Addendum No. 2
Verdi Dam Repairs 2014-2015
PWP No: WA-2015-003
October 8, 2014

Verdi Dam Repairs- Bid Item Clarification (Revised)

Bid Item Number 4

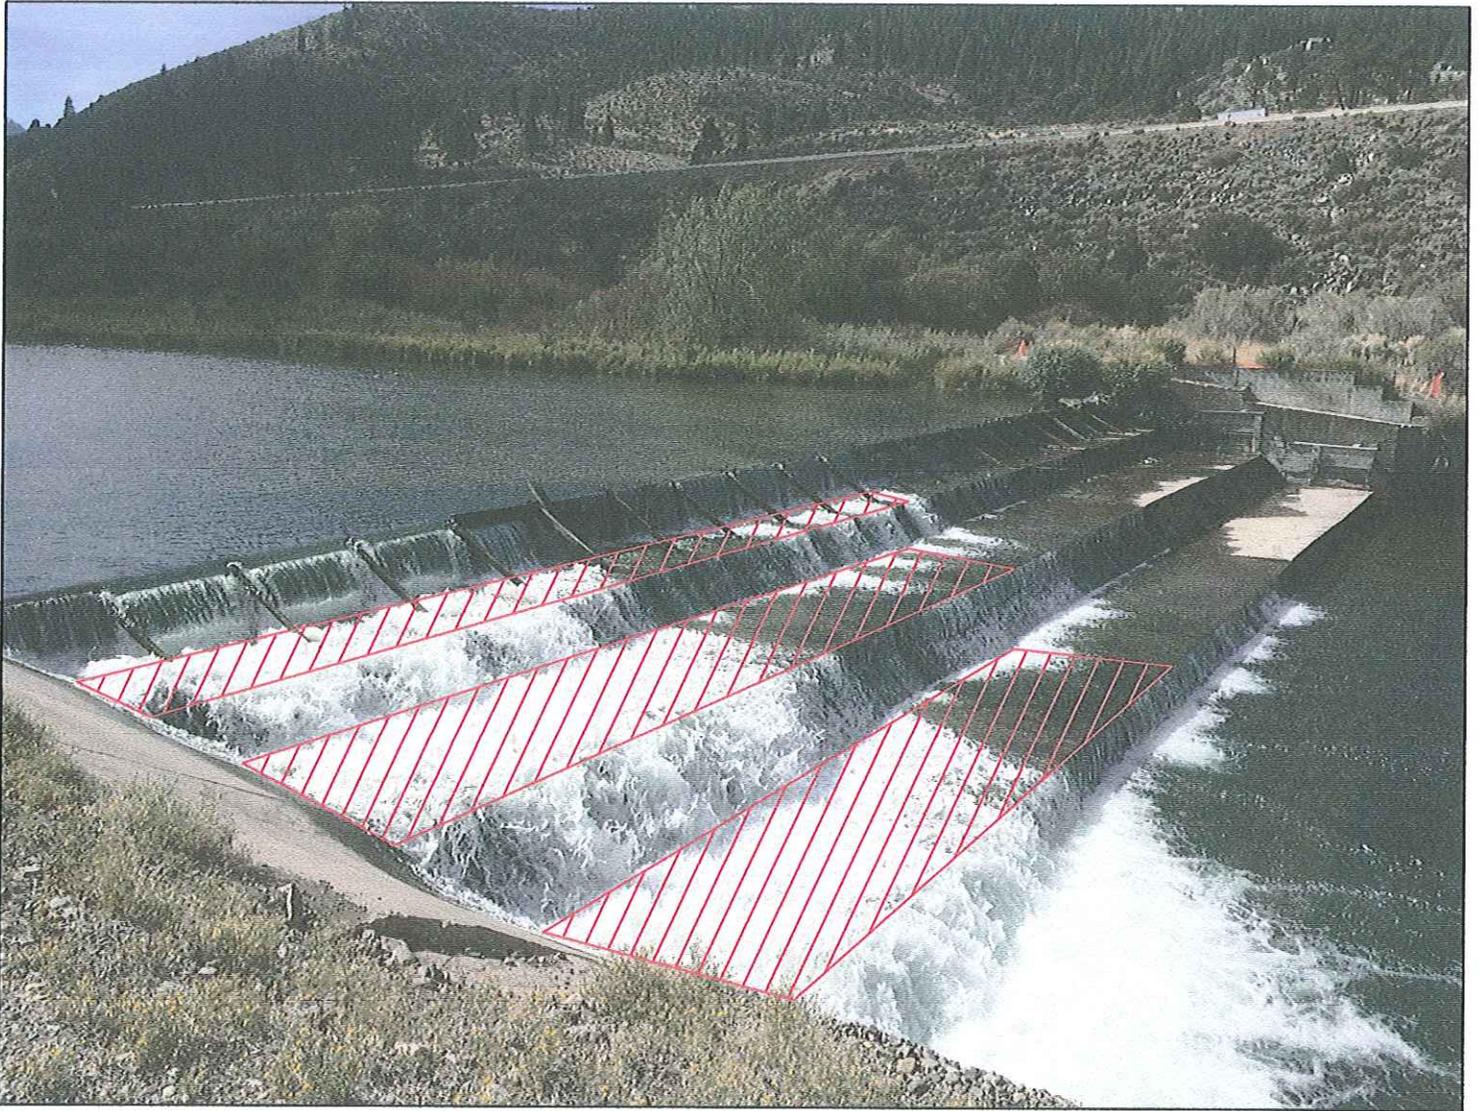
Contractor shall provide all material, labor, equipment and other resources to complete repairs to the Verdi Dam Fish Ladder. Timber shall be untreated #2 or better Douglas Fir. Nails will be 90#. Repairs entail the following (see attached photo):

- Remove existing fish ladder and reconstruct in-kind.
- Remove and replace uppermost stop-log panel.
- Install new timber stop-log supports on dam side of ladder with slot configuration accommodating 6"x8" timber.
- Do not construct stop log panels below the uppermost stop log panel.
- All attachment hardware shall be galvanized including carriage bolts, washers and nuts. Counter sink nut end of carriage bolt so that hardware does not protrude into the passage ways on either side of the ladder.
- Utilize galvanized carriage bolts, washers, and nuts. Counter sink nut end of carriage bolt so that hardware does not protrude into the passage ways on either side of the dam.
- Provide as-built drawing of fish ladder construction.

REPAIRS TO VERDI DAM - (DAM WIDTH APPROXIMATELY 180 FEET)
TMWA WILL DIVERT AS MUCH WATER AS POSSIBLE THROUGH THE VERDI
HYDRO CANAL.

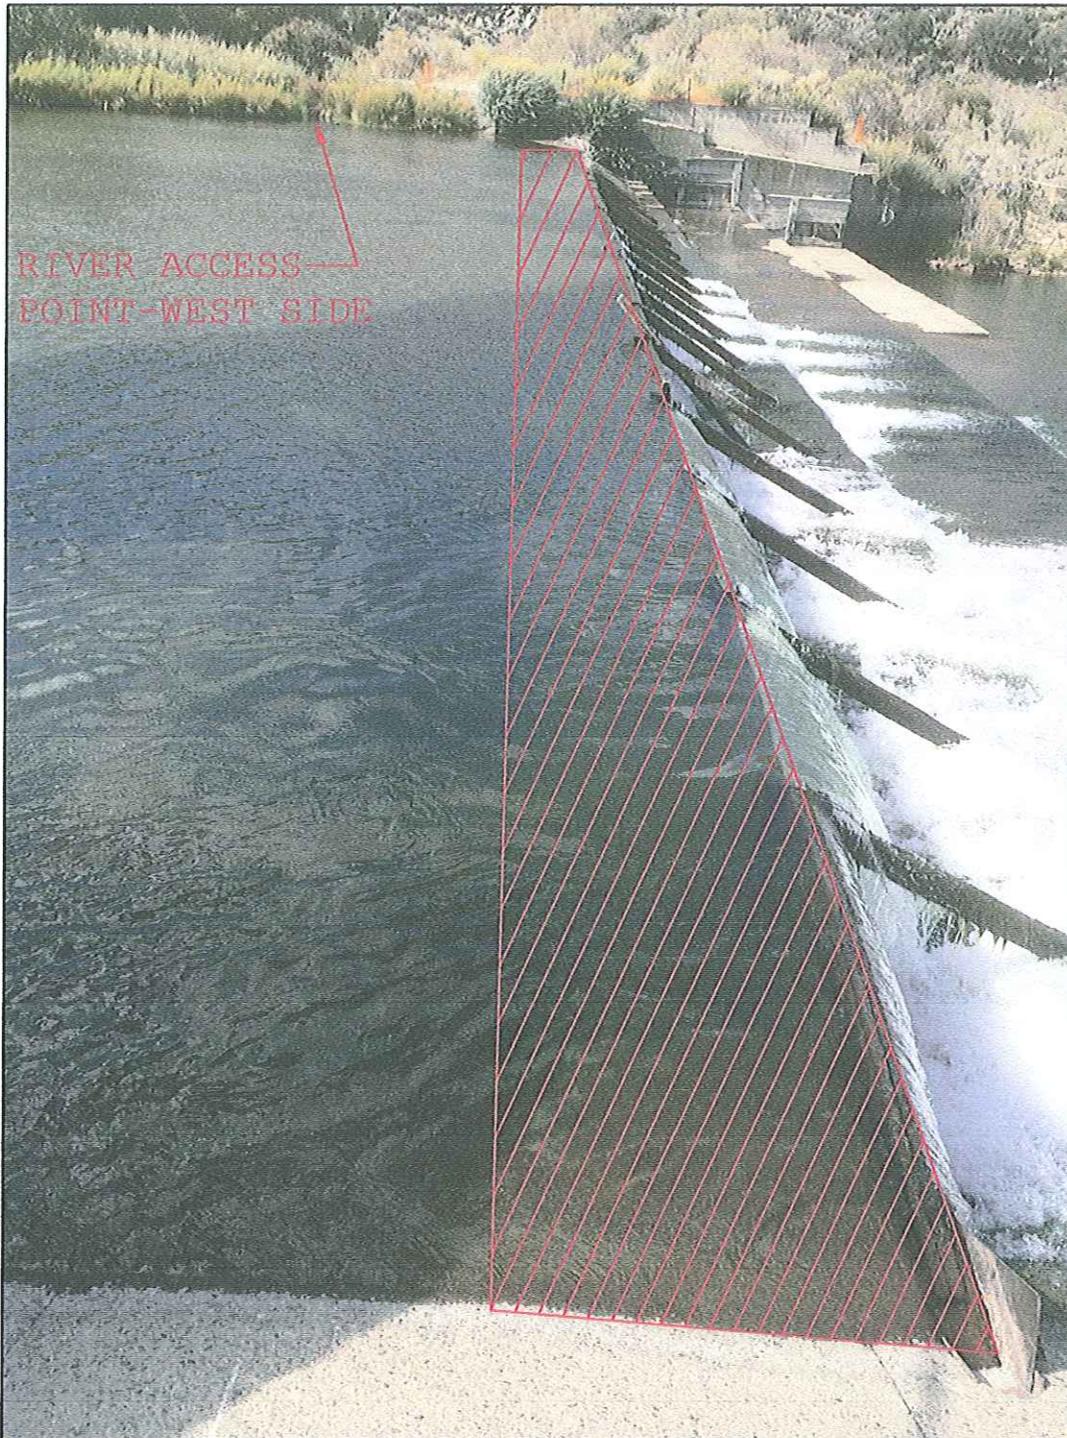
- * COVER APPROXIMATELY 90 FEET OF EXISTING DECKING ON EACH OF THE UPPER THREE DECKS AS SHOWN ABOVE. CONTRACTOR TO PROVIDE ALL TIMBER AND NAILS. TIMBER TO BE 3"X12"X12' UNTREATED #2 OR BETTER DOUGLASS FIR. 90# NAILS TO BE UTILIZED IN ATTACHING NEW TIMBER TO EXISTING DECKING. NEW TIMBER TO BE INSTALLED BY OVERLAPPING EXISTING TIMBER DECKING JOINTS.

- * REPLACEMENT OF EXISTING DECK BOARDS SHALL BE AS DETERMINED BY THE TMWA PROJECT REPRESENTATIVE.

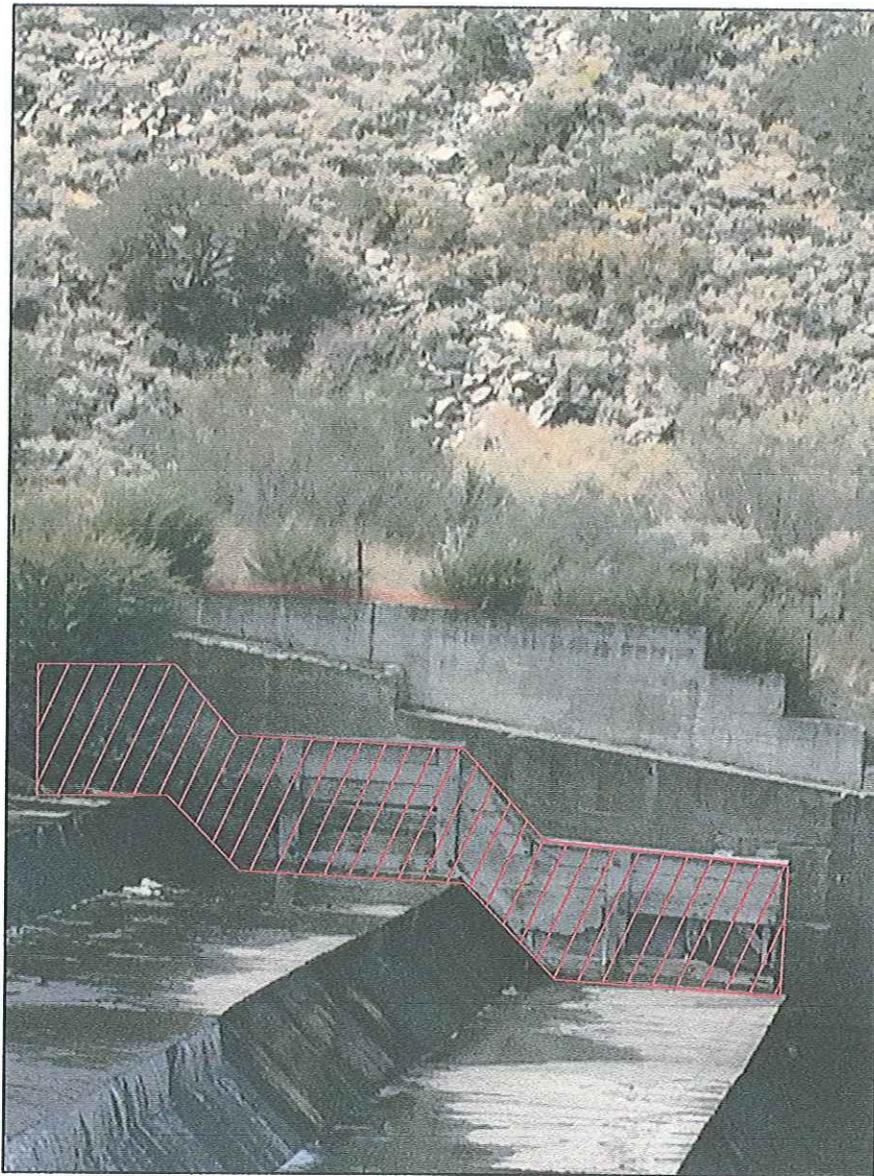
CONTRACTOR TO REMOVE AS MUCH SILT BUILD-UP FROM BEHIND THE DAM SPLASH BOARDS AS IS NECESSARY TO REMOVE AND REPLACE ALL SPLASH BOARDS AND STOP LOGS AT TOP OF FISH LADDER.

CONTRACTOR CAN ACCESS THE RIVER WITH EQUIPMENT FROM THE FREEWAY SIDE OF THE DAM THROUGH THE DITCH LOCATED UPSTREAM OF THE DAM.

SEDIMENT AND BRUSH CAN BE DISPOSED OF ON SITE IN AN AREA DESIGNATED BY THE TMWA REPRESENTATIVE. BRUSH CAN BE REMOVED, TRACK ROLLED, AND BURIED BENEATH SEDIMENT.

REPLACE ALL SPLASH BOARDS ON TOP OF DAM. SPLASH BOARDS ARE 3"X12"X8'. (CONTRACTOR TO VERIFY REQUIRED LENGTHS)
REPLACE ALL 4"X6" SPLASH BOARD BRACING. INTEGRITY OF SPLASH BOARD BRACE PLATES TO BE EVALUATED AND CONTRACTOR TO REPLACE AS DIRECTED BY THE TMWA REPRESENTATIVE.

FISH LADDER REPAIRS - NEW LUMBER, NAILS, AND ALL HARDWARE PROVIDED BY CONTRACTOR.

- * REMOVE EXISTING FISH LADDER AND RECONSTRUCT IN KIND WITH NEW #2 OR BETTER UNTREATED DOUGLASS FIR LUMBER.
- * REMOVE AND REPLACE UPPERMOST STOP LOG PANEL.
- * INSTALL NEW TIMBER STOP-LOG SUPPORTS ON DAM SIDE OF LADDER WITH SLOT CONFIGURATION ACCOMMODATING 6"X8" TIMBER. DO NOT CONSTRUCT STOP LOG PANELS BELOW UPPERMOST STOP LOG PANEL.
- * ALL ATTACHMENT HARDWARE TO BE GALVANIZED.
- * UTILIZE GALVANIZED CARRIAGE BOLTS, WASHERS, AND NUTS. COUNTER SINK NUT END OF CARRIAGE BOLT SO THAT HARDWARE DOES NOT PROTRUDE INTO THE PASSAGE WAYS ON EITHER SIDE OF THE LADDER.
- * PROVIDE AS-BUILT DRAWING OF FISH LADDER CONSTRUCTION.
